Name: Sundance Meadows – Highway 50 / Linden Street

REVIEW COMMENTS

FILE #86-94

TITLE HEADING: Preliminary Plan/Plat - Sundance
Meadows Subdivision

PRELIMINARY PLAN
SUNDANCE MEADOWS SUBDIVISION
GRAND JUNCTION, COLORADO

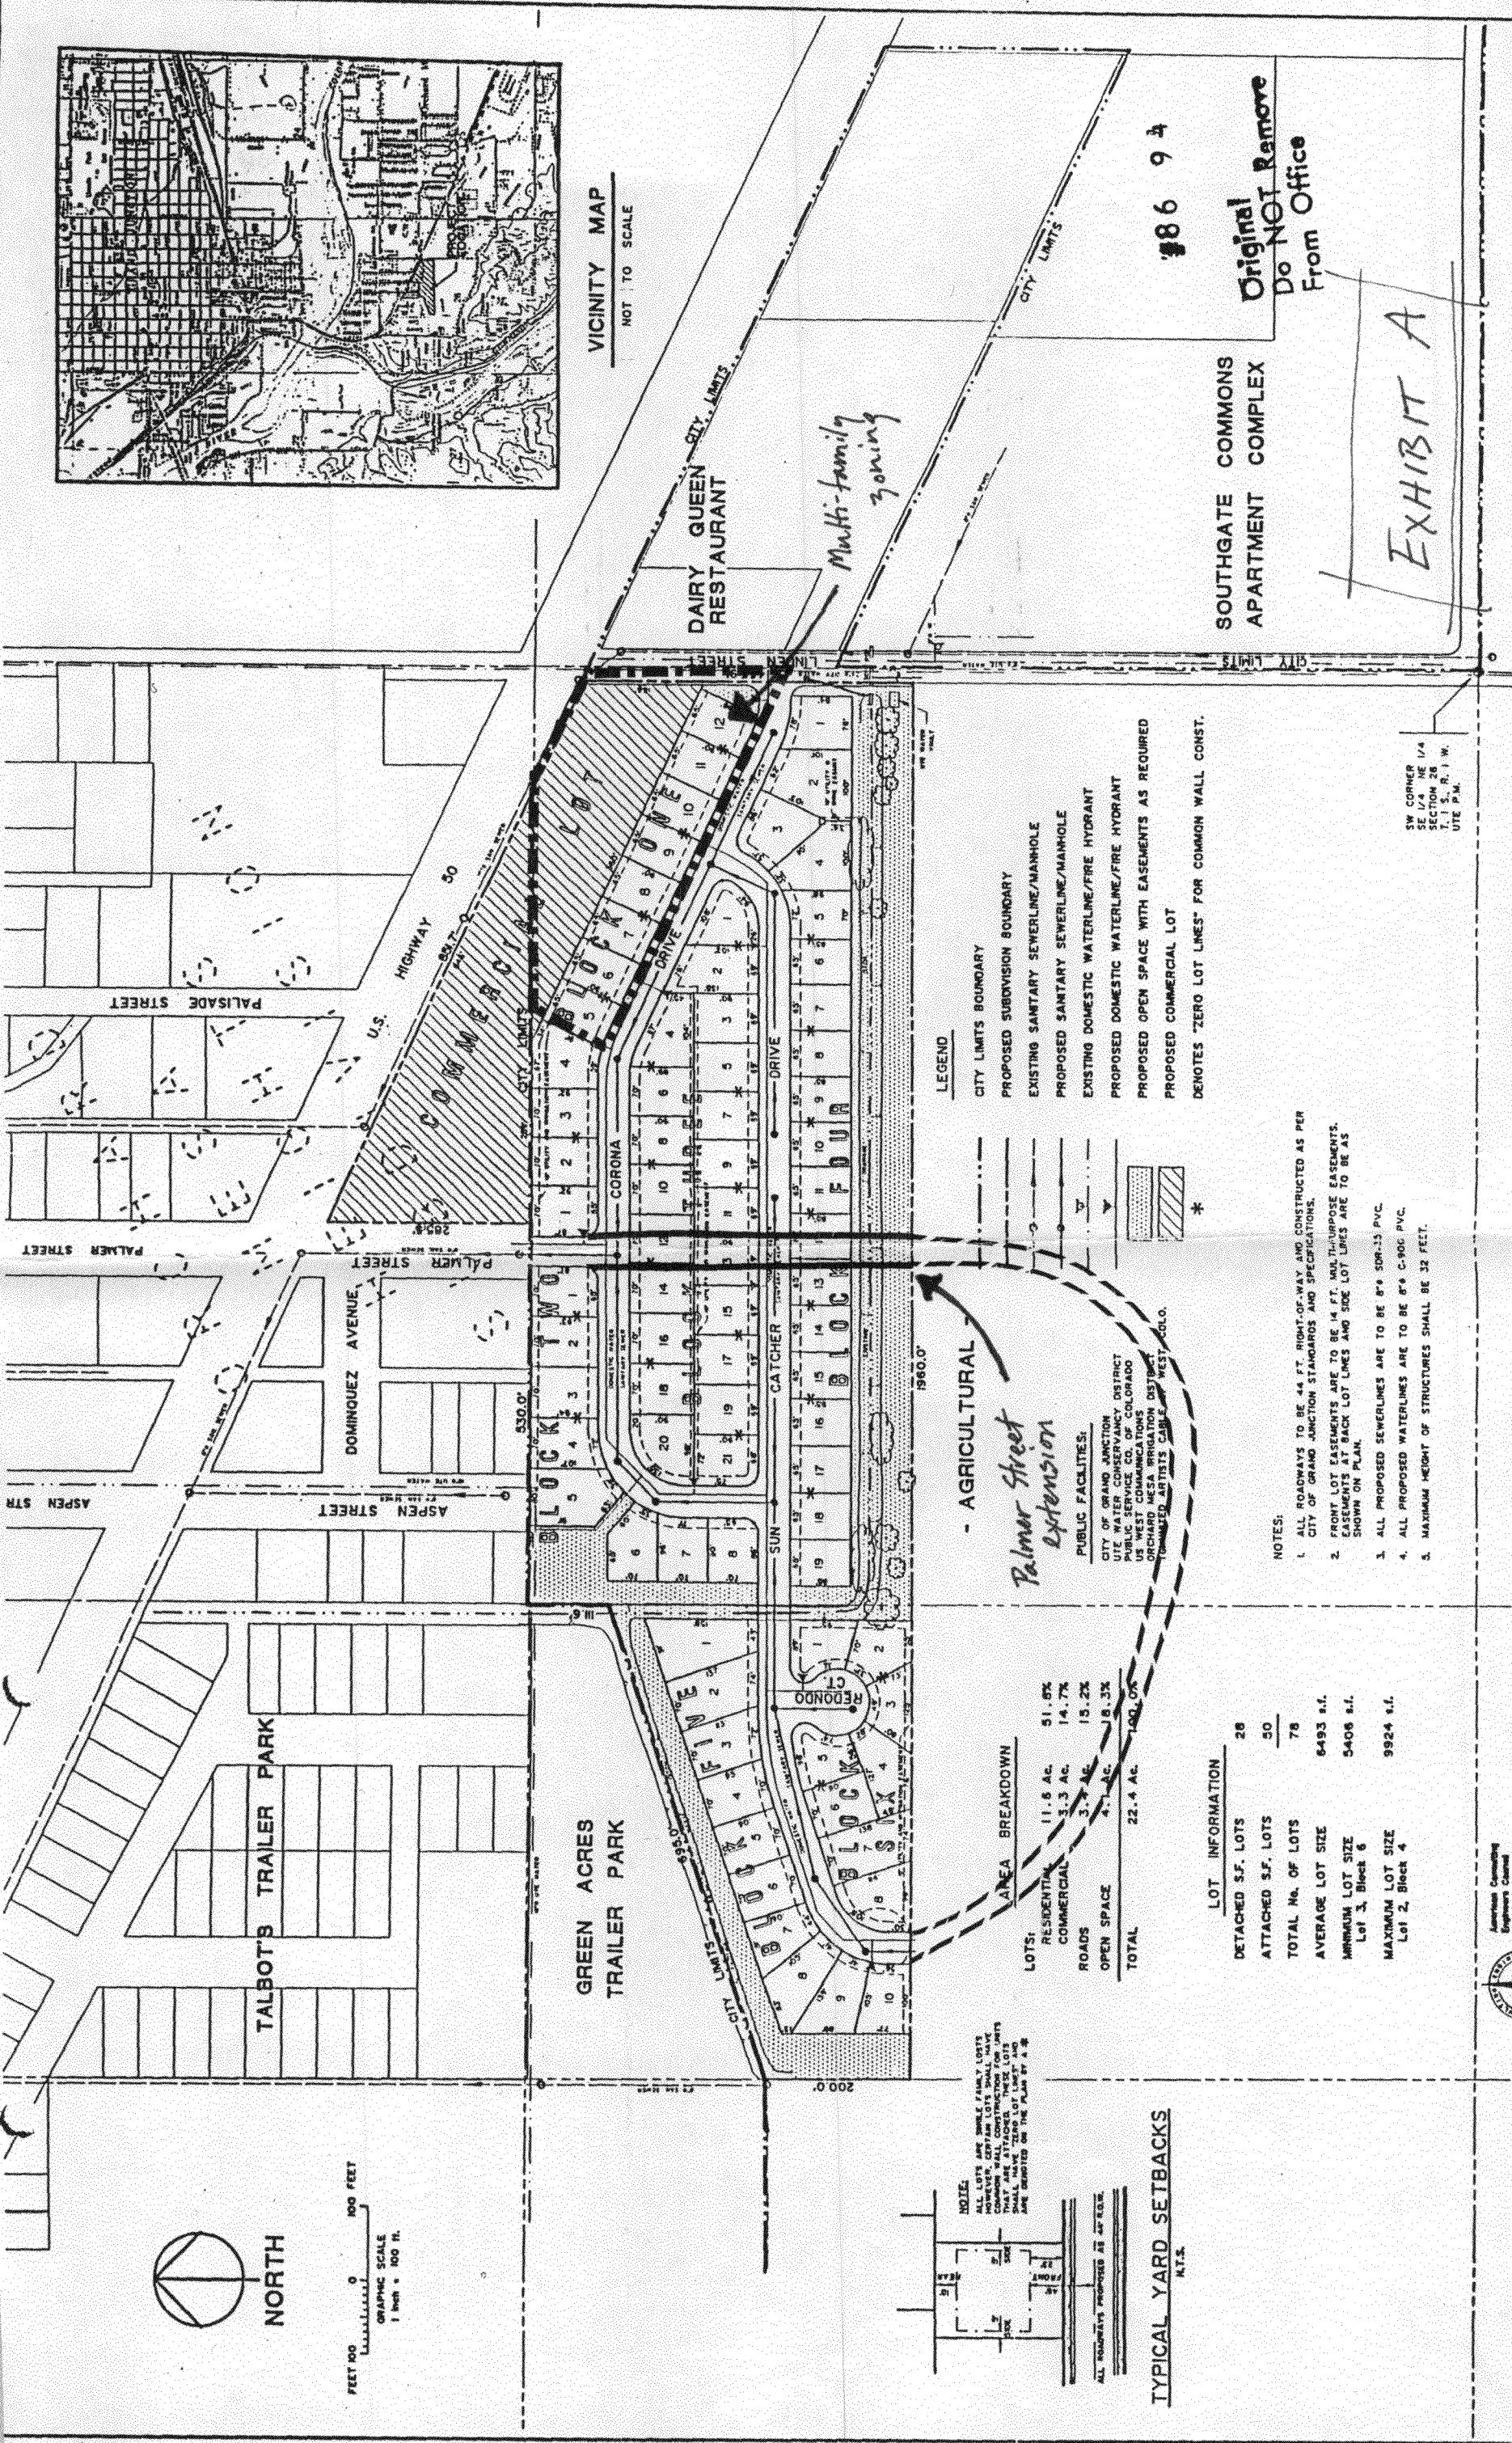
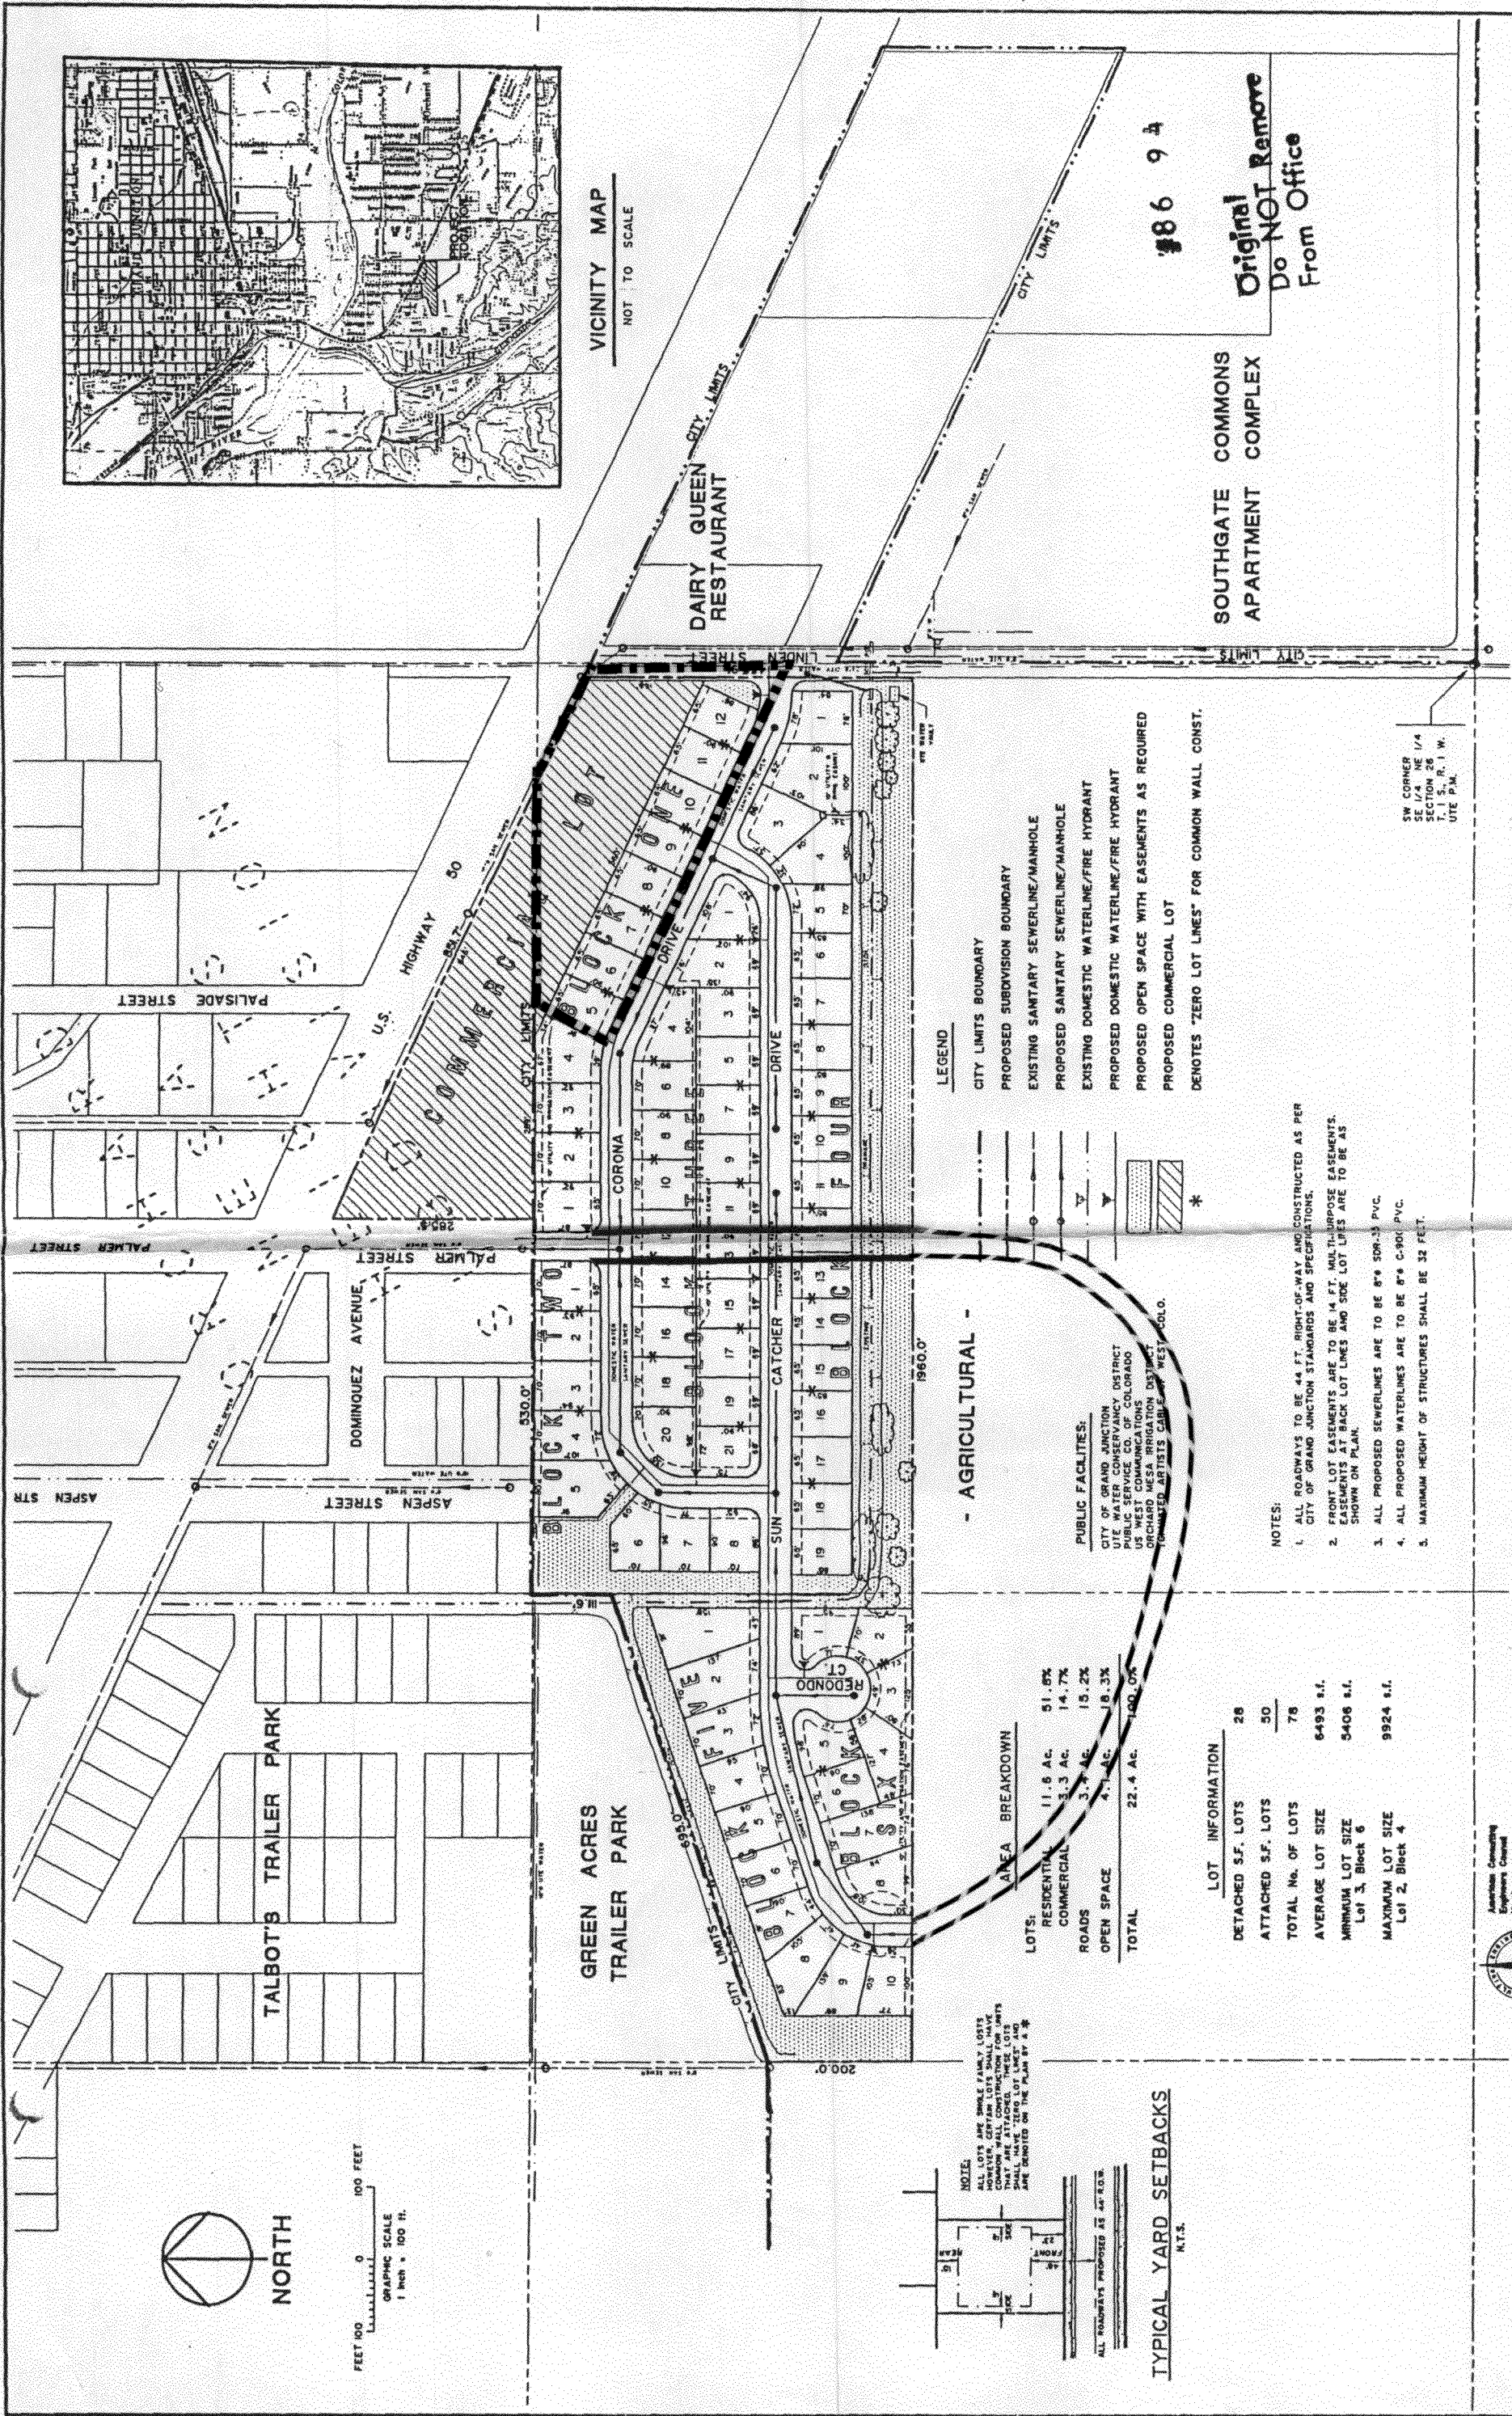
Submit a utility composite for scale for our review and approval.

1. Final should show adequate buffering and screening between residential and commercial uses.
2. Is the commercial area included in the PUD rezoning? If so, what are the proposed uses.
3. We note that the traffic study is to be provided at final and reserve comments on the turn lanes and/or traffic control pending receipt of that study.
4. Annexation should include the full right-of-way width of Linden Avenue.
5. Proposed phasing should be indicated on the preliminary plan.

ELECTRIC & GAS: Require 14' front lot line multi-purpose easement to be added to the following lots:

- The westerly 14 feet of Lot 1, Block 1
- The easterly 14 feet of Lot 1, Block 2
- The southerly 14 feet of Lot 8, Block 2

1) Palmer Street should extend through the site in order to connect to the vacant parcel south of the proposed subdivision. The preliminary plan for Heritage Hills Subdivision proposed to do this. Subdivision plat should be re-designed to achieve this.

3) Under the previous proposal, Heritage Hills Subdivision, Palmer Street extended through the subdivision in order to connect to the vacant parcel south of this site. Sundance Meadows Subdivision does not provide for this kind of through connection. Based on comments from the City Engineer and because of the need to create efficient land divisions to meet present and future circulation and access needs, Sundance Meadows would have to be re-designed to achieve the desired extension of Palmer Street or some acceptable alternative.

5) No phasing of development has been indicated by the applicants. The phasing sequence should be identified on a re-submitted preliminary plat.

6) A landscaping/screening for separating the commercial and residential areas is needed. This will have to be submitted and reviewed as part of the second review of the preliminary plat.

The Preliminary Plan submitted included the utilities shown at a 100 scale. However a complete Utilities Composite will be submitted at Final.

1. Final submittal will show proposed buffering and screening.
2. The commercial area will not be included in the PUD, however it is in an area that is currently zoned commercial. As of this date there is no proposed use for the commercial area, it is simply being retained as it is currently zoned to provide for a buffer between the residential area and the highway. Any future proposed use of the area will be required to be reviewed by the City at that time.
3. No response necessary.
4. No response necessary.
5. Proposed phasing will be added to the Preliminary Plan.

The easements requested for will be added.
